RE: **Lot 26 Block 1 Unit 22 SAD 228
6515 Azor NW
Volcano Cliffs Subdivision
Grading and Drainage Plan
Engineers Stamp Date 11/4/2020 (D10D003H11)**

Based upon the information provided in your submittal received 11/5/2020, this plan is approved for Grading Permit.

ENGINEER'S SEAL 	6515 AZOR	DRAWN BY WCVJ
	GRADING AND DRAINAGE PLAN	DATE 11-03-20
11/4/20	Rio Grande Engineering 1606 CENTRAL AVENUE SE SUITE 201 ALBUQUERQUE, NM 87106 (505) 872-0998	2102089-LAYOUT-11-03-20
DAVID SOULE P.E. #14522		SHEET #
		JOB # 2102089

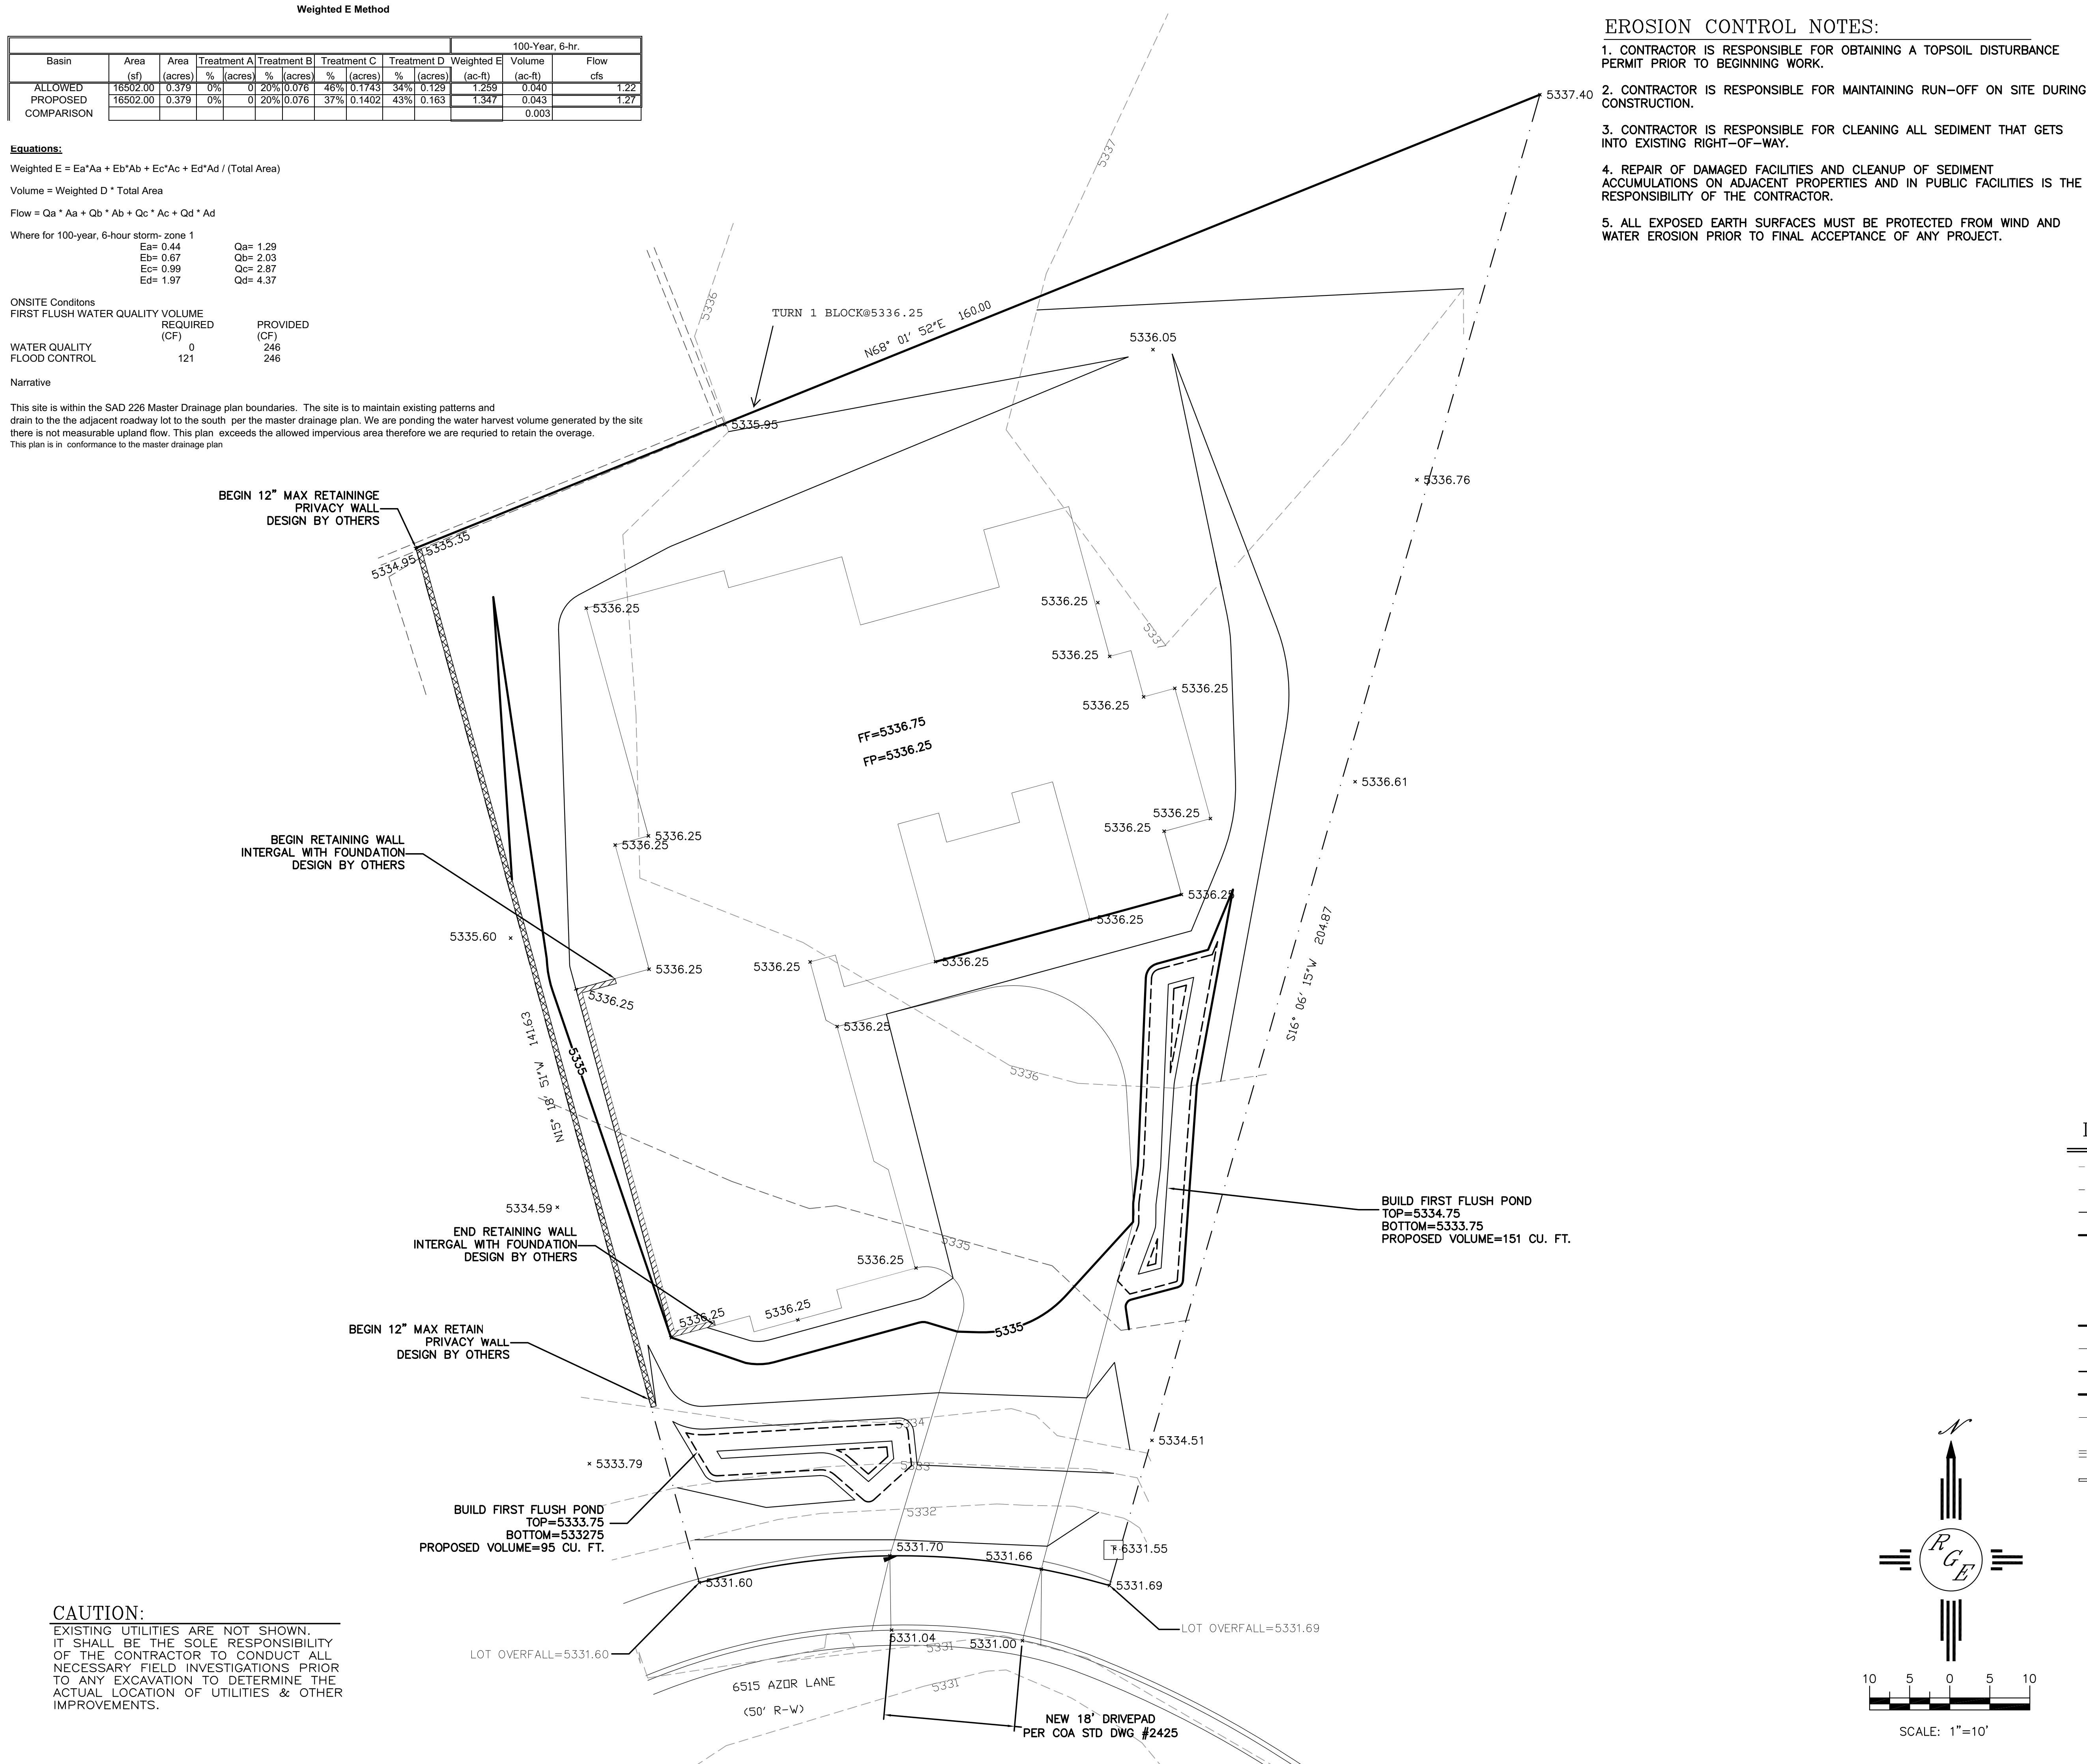
Prior to Building permit approval a Pad Certification will be required, provided by the Engineer or a registered Land Surveyor.

Advise the owner contractor not to use dirt as a ramp to climb the curb, use lumber or crusher fines for this purpose.

Reiterate to the Owner/Contractor that a separate permit for a garden/retaining wall must be obtained with the approved G&D plan and Pad Certification. Also, if a swimming pool is to be placed the grading and drainage plan will change and will need to be resubmitted.

Prior to Certificate of Occupancy release, Engineer Certification per the DPM checklist is required.
